PROJECT NAME BL072 -CHEMISTRY ADDITION – REPLACE AHU-1 THROUGH 4 – PHASE 2
IU PROJECT NO. 20250507 | CREATIVE ENGINEERING PROJECT NO. 2025-035.AH2
ADDENDUM NO. 3
DATE: 4/21/2026

INDIANA UNIVERSITY CAPITAL PROJECTS CONSTRUCTION FENCING SCREEN STYLE GUIDE 05/04/2020

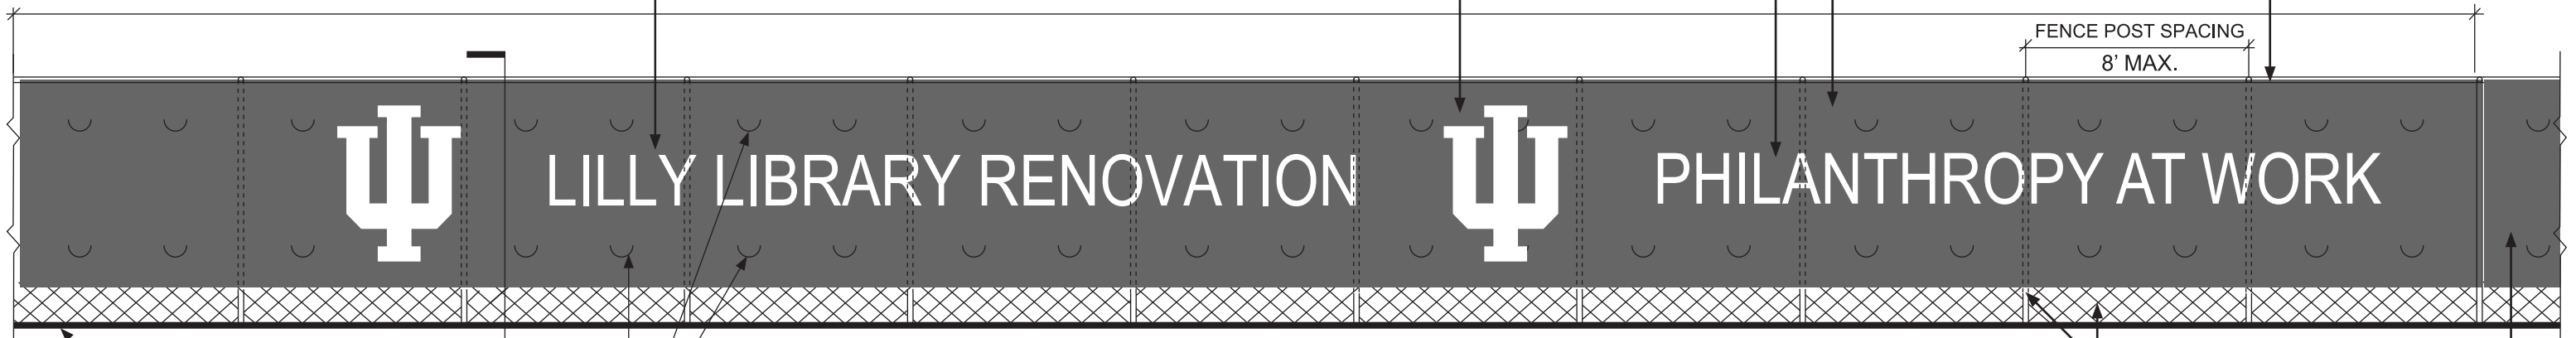
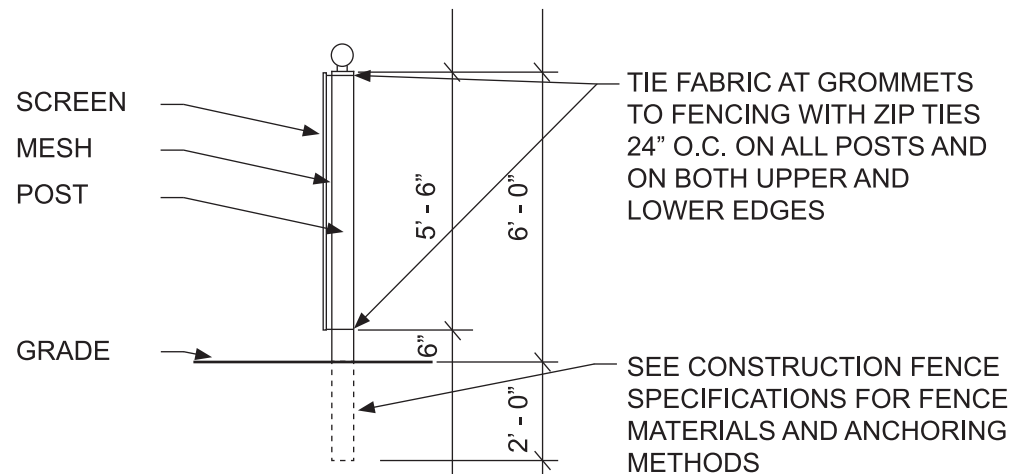
- 1.1 A dumpster will be permitted per the attached site plan (shown as a white rectangle) for the heavy demolition period, roughly from September 1 until December 31, 2026 – *Attachment A* (Site Photo). Successful bidder will coordinate exact dumpster sizing and placement with Construction Manager and Building Manager. 6 FOOT temporary chain link fence and Pantone 201 privacy screen (per IU standard) - *Attachment B* - shall be provided around dumpster, and locked when not in use.
